DEVELOPMENT APPLICATION ASSESSMENT REPORT

Application Number:	DA2020/1206
----------------------------	-------------

Responsible Officer:	Kent Bull
Land to be developed (Address):	Lot H DP 396772, 21 Waterview Street MONA VALE NSW 2103
Proposed Development:	Alterations and additions to a dwelling house including a secondary dwelling and swimming pool
Zoning:	R2 Low Density Residential
Development Permissible:	Yes
Existing Use Rights:	No
Consent Authority:	Northern Beaches Council
Land and Environment Court Action:	No
Owner:	Daniel Robert Cheetham Amy Cheetham
Applicant:	Marcus Edward Betts

Figure 1: Image taken from the existing rear deck looking towards No. 19 Waterview Street.

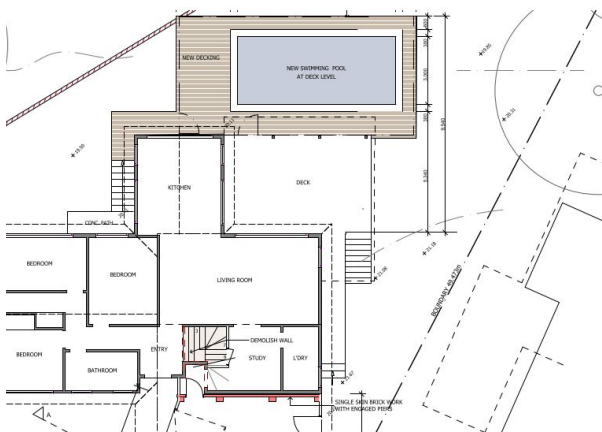
The proposed swimming pool and associated decking is seen to be technically non-compliant with the control that requires direct views of any private open space or any habitable room window within 9m to be restricted by appropriate privacy measures. The control also states to elevated swimming pools and decks should incorporate privacy screens were necessary.

In order to optimise visual privacy between the occupants of No. 21 Waterview Street and No. 19 Waterview Street, the Applicant has agreed to accommodate a fixed privacy screen along the length of the north-eastern side of the proposed pool deck (coping). This change is seen to be an effective measure to limit the extent of privacy impacts between the bedroom and deck at No. 19 Waterview Street and the proposed swimming pool at the subject site.

Figure 3: Area shaded red depicting the extent of the non-compliance with the 6.5m front building line control.

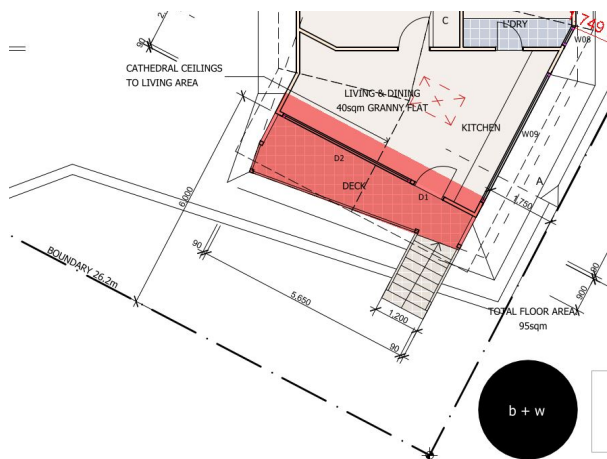
The proposal is seen to be technically non-compliant with the 6.5m front building line requirement, being 4.3m to the balcony of the secondary dwelling and 6m to the outerwall (southern elevation) of the secondary dwelling.

In this regard, the proposed secondary dwelling is located above an approved double garage (under construction) and therefore will result in minimal environmental impact. The development will not exceed a maximum of two storeys and is seen to be integrated with the landform and landscaping on site.

Consideration has been given to the existing setbacks of properties either side of the subject site. In this regard, No. 19 Waterview Street is measured at 6.2m from the front boundary and No. 23 Waterview Street is indicated as being approximately 3.8m from the front boundary. As such, the proposed development being measured at 4.3m to the balcony and 6m to the outerwall (southern elevation) of the secondary dwelling to the front boundary is not seen to be inconsistent with the prevailing setback. Whilst there are a number of examples of single storey dwelling houses along the northern side of Waterview Street, there is an increasing emergence of two storey dwelling houses within the immediate vicinity of the site.

Based on the above, the proposed development is considered acceptable in merit and consistent with the outcomes of this clause in this particular instance.
